**CITY OF SACRAMENTO PLANNING COMMISSION  
RECORD OF DECISION  
New City Hall, 915 I Street, 3rd Floor, Sacramento, CA 95814**

Project Name: SLCC Recycling/Sorting Facility  
Project Number: P07-099  
Project Location: 6100 27TH ST  
Assessor's Parcel No.: 036-0031-026-0000  
Applicant: Anita Williams 1919 19th Street, Sacramento, Ca 95814

**RE: SLCC Beverage Container Sorting & Recycling Facility (BCSFR)  
6100 27<sup>th</sup> Street, Sacramento, CA.  
Response to City Staff Comments P07-099**

Exhibit 1D – Landscape Plan

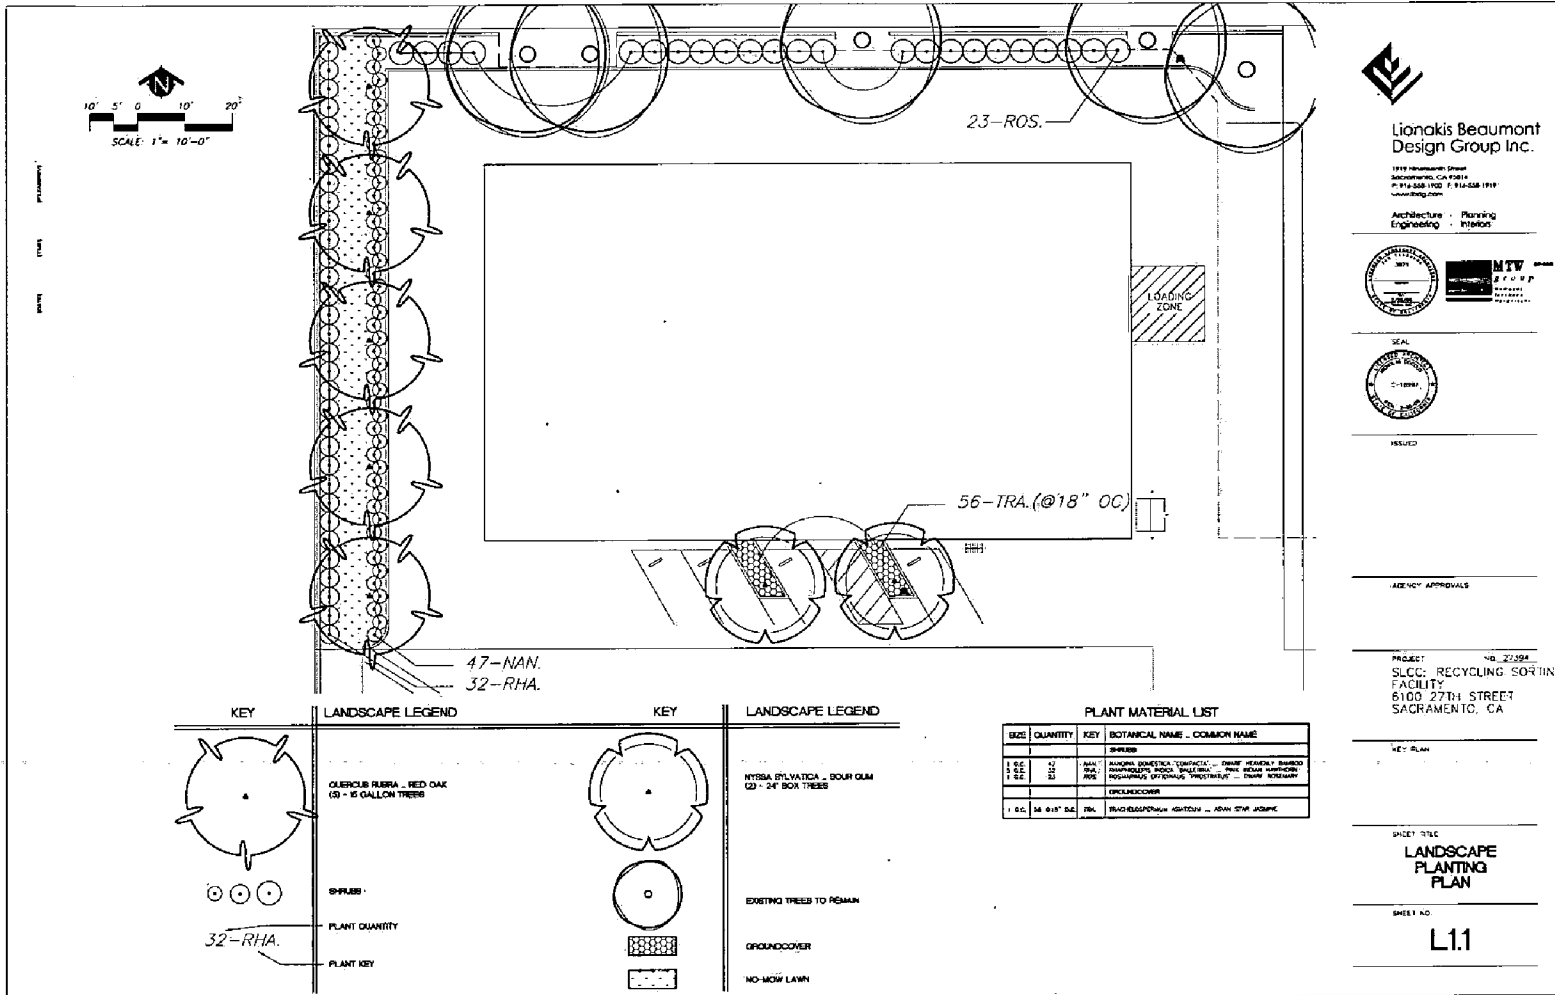
2. **Revise landscape plant to show three large canopy species trees at a spacing of 40' in the 12' wide planter west of the proposed building, (attached red lined landscape plan specifies appropriate species and spacing).**

4. **Consolidate two small tree planters to create one 8' wide planter near the center of the parking stalls.**
  - Will provide shading requirements to city standards.

5. **Add one planter on east and west side of stalls per red line. An 18" to 20" wide strip of paving can be installed for driver/passenger step out.**

- Can not comply due to building operation's flow.
6. **Revise landscape plan to show three semi columnar trees (see species selection) in planters south of the building.**

1. **Plant three 15 gallon or 24" box Willow Oak (*Quercus phellos*) or Tupelo (*Nyssa sylvatica*) in south parking area planters.**
  - Will consider depending on canopy size.
2. **Plant three 15 gallon or 24" box Shumard Oak (*Quercus shumardii*) or Turkey Oak (*Quercus cerris*) 40' apart in west planter.**
  - Will consider depending on canopy size.

- Deferred submittal landscape plans shall reflect change.
3. **Relocate two 12' wide sliding doors to be 7' from perpendicular walls per redline.**
  - Can not comply due to building operation's flow.
